**Adjustment Procedures for Amplifier Group AN/GSA-33 and Audio Amplifier AM-413A/G Background.**

**SERVICE NOTES**

NAVSEA 0967-LP-000-0010

Figure 1. Case modification AN/PRC-39.

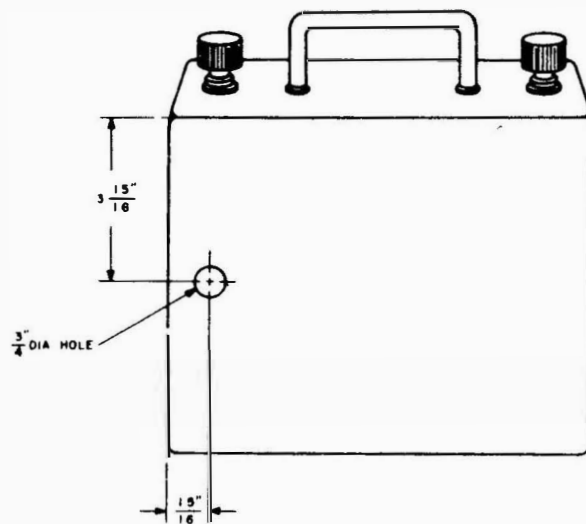
**Transmitter-Receiver AN/PRC-39—Modification of Case to Permit Tuning of Final Tank Circuit**

The Bureau of Ships has been notified by NAS Brunswick that difficulty exists in tuning the final tank circuit of the AN/PRC-39. Each time the metal case is removed and replaced, the capacity effect of the metal case will detune the final tank circuit. Drill a hole of sufficient size in the case directly over the final tank circuit to allow the final tank circuit to be resonated for maximum RF output upon reinsertion into the case. This hole, when not in use, is sealed with a rubberized knock-out plug to maintain watertight integrity of the equipment.

Drill a  $\frac{3}{4}$ -inch-diameter hole in the aluminum case directly over the final tank circuit in accordance with figure 1 of this article. Insert a  $\frac{3}{4}$ -inch rubberized knock-out plug into the hole. The stock number of the plug is: KZ5340-893-8798. (608)

Figure 1. Location of Drilled Hole in Module Top Plate

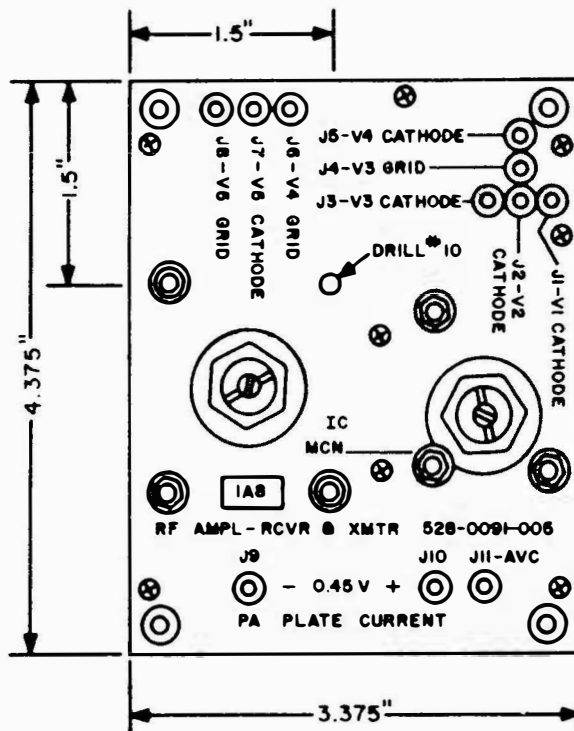
Activities servicing Radio Sets AN/PRC-41 are advised of a modification to the RF and power amplifier module (1A8) which permits replacement of a ceramic screw in the grid stator assembly (1A8 MP30). Access to the screw is normally blocked by the module top plate (1A8 MP34) and requires disassembly of the module to replace in the event of failure. Access can be obtained by drilling a hole through the top plate, as shown in figure 1.

with a #10 drill bit. Use a 6-32 tap to remove the broken ceramic screw and to clean out the threads. Insert the new ceramic screw and tighten very carefully with a screw-driver which is inserted thru the drilled hole. This hole will not affect the operation of the RF and power amplifier module but will reduce the time required to make the repair. Implementation of this modification is recommended for all Radio Sets AN/PRC-41 which require replacement of the ceramic screw in grid stator assembly (1A8 MP30). (836)

FIG. 3 CONNECTION OF EXTERNAL CAPACITORS

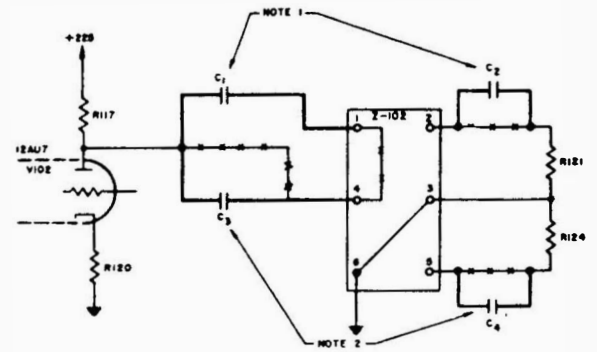
If a replacement is not readily available, emergency repairs may be made on some filters where the frequency of peak response has shifted downward. The emergency

repairs are made by connecting external capacitors in series with the filter. The schematic diagram of the connections is shown in figure 3. The values of capacitors, which will give optimum performance, are best determined by trial and error. To select the range of values to be tried, Table IV may be used as a guide. The test procedure, to determine the performance of the filter should be repeated after each group of external capacitors have been connected into the circuit. If an improvement is noted, the capacitors may be bolted to the chassis and any splices covered with spaghetti. The physical dimensions of the capacitors, are shown in figure 4.

NOTES:  
 1. ADD CAPACITORS C1 & C2 (SEE TABLE III) TO RAISE THE FREQUENCY OF THE MARK FILTER  
 2. ADD CAPACITORS C3 & C4 (SEE TABLE III) TO RAISE THE FREQUENCY OF THE SPACE FILTER

FIGURE 1

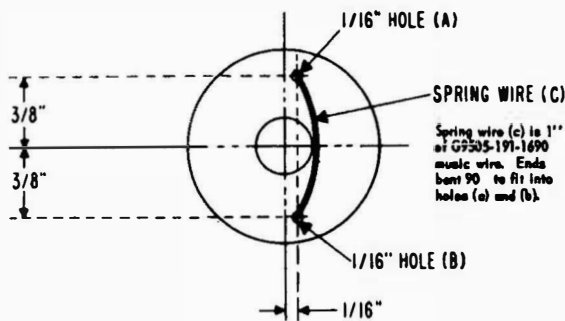
(b) S-101C Channel selector C acted much as did Channel selector A. This problem was more pronounced in positions 1 and 2 which affected L-101 and L-102 and was more critical than the situation described above. The rollers may be stabilized on the stationary shafts by the addition of a spring loaded contact as illustrated in Figure 1."

It is recommended that ships experiencing difficulty with the AN/SRA-20 coil rollers in the R F tuner unit, modify these rollers as described.
